**ATTORNEY GENERAL  
DEPARTMENT OF JUSTICE**

**Re: SEC Docket No. 15-04 – Application of Public Service Company of New Hampshire d/b/a Eversource Energy for a Certificate of Site and Facility for the Construction of a New 115 kV Transmission Line from Madbury Substation to Portsmouth Substation (Seacoast Reliability Project);  
Comments of Counsel to the Public to NH Department of Environmental Services**

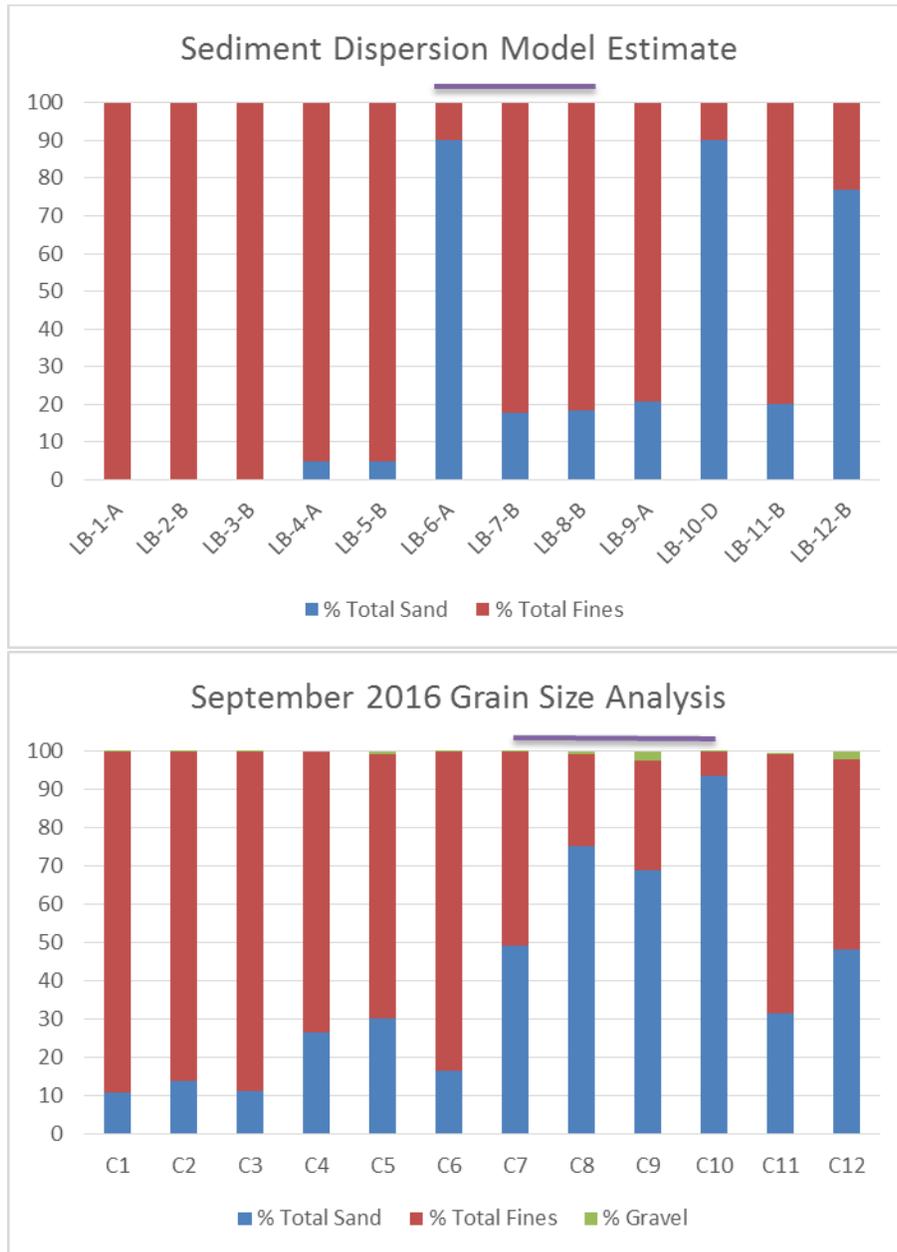
- ESS compared the grain size distributions provided in Appendix 35, Table 3-2 with the grain size analysis results provided in Table 3 of the 2016 sediment sampling report to determine the % Sand and % Total Fines in each. As shown in the graphs below, the grain size analysis results indicate a higher percentage of sand in the sediment than the 2014 visual observations, which could reduce the predicted suspended sediment concentrations and/or the deposition of suspended sediment

away from the jet plow trench. The purple line indicates the samples that are located in the Little Bay deep channel. Based on this comparison, it is possible the sediment dispersion modeling may over predict the levels of suspended sediment concentration and deposition resulting from jetting installation of the submarine cable in Little Bay, which would therefore be conservative.

- The Applicant should consider performing another run of the model using the grain size analysis results from the September 2016 sampling or from additional sampling that includes the entire depth of sediment disturbance from the jet plow.
